AERAZUR 2 rue Maurice Mallet 92130 Issy les Moulineaux Tél. 33 1 41 23 23 23 Fax 33 1 46 48 83 41	<h1>Service Bulletin</h1> <p>Title : Improvement of the Harness/container Titre: amélioration des sacs/harnais biplaces</p>	BS-25-63-34 Date: 31/07/2007 Page 1/8
----------------------------------------------------------------------------------------------------------------------	----------------------------------------------------------------------------------------------------------------------------------	-------------------------------------------------

Block 1	<u>Technical Background</u>	
a)	Applicability	: <u>Dual harness/containers</u> : 740-1 (ATOM TANDEM) and MMS 740-2 manufactured before 2002 as presented in page 2.

Identification of the containers

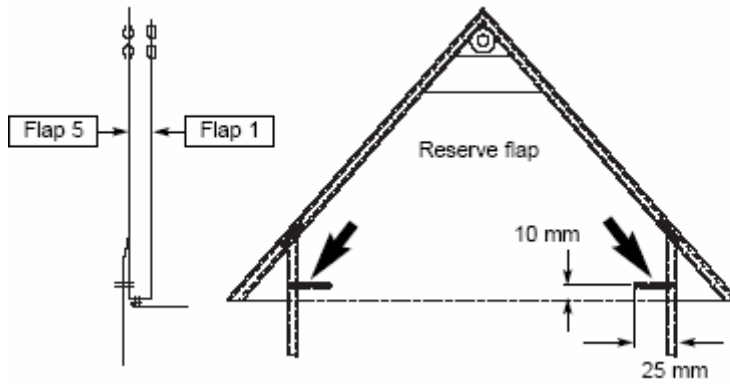
This Service Bulletin concerns these two designs:

This design is not concerned by this Service Bulletin :

Please consider the orientation of the inner flap between the second and the last generation

Improvement:

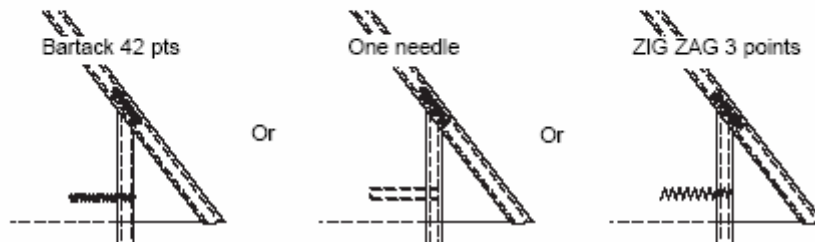
Make a stitching as like drawing upper.

Sewing machine: Bartack 42 pts / One needle / ZIG ZAG 3 points.
Thread: Polyamide 30/3 or size "E" nylon thread

Identification du sac/harnais

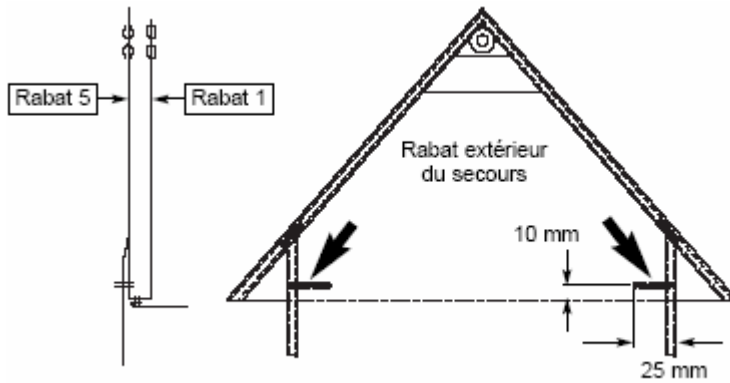
Ce Bulletin Service concerne ces deux définitions:

Cette définition n'est pas concernée par ce Bulletin Service :

Attention à porter sur l'orientation du volet de protection entre la seconde et dernière génération.

Amélioration:

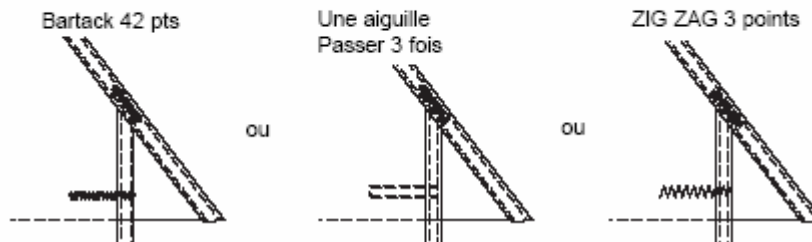
Effectuer la couture selon les dimensions mentionnées ci-dessus.

Machine à coudre: Bartack 42 pts / Une aiguille / ZIG ZAG 3 points.
Fil: Ployamide 30/3 ou Size "E"
